Access Compliance Report

Public Rights-of-Way

(Curb Ramps)

| Intersection ID: 18726 | Main Street: TYVOLA_RD | Cross Street: OLD_PINEVILLE_RD | Location: SW |

| ADA ID: CC916F78E265 | Ramp Type: Perp | Initial Pass/Fail: Fail | Overall Compliance: No |

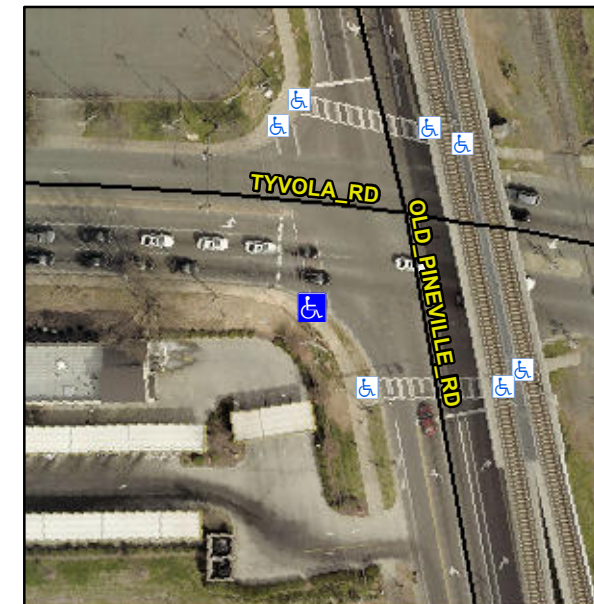
R304.5.1, R304.5.3

| Compliance | Description | Data | Compliance | Description | Data |
|------------|-----------------------|-------|------------|-----------------------------|------|
| N/A | Ramp Length (in) | 105.0 | Yes | Ramp Slope (%) | 5.2 |
| No | Ramp Width (in) | 44.0 | No | Ramp XSlope (%) | 5.0 |

Remove & Replace Entire Ramp.
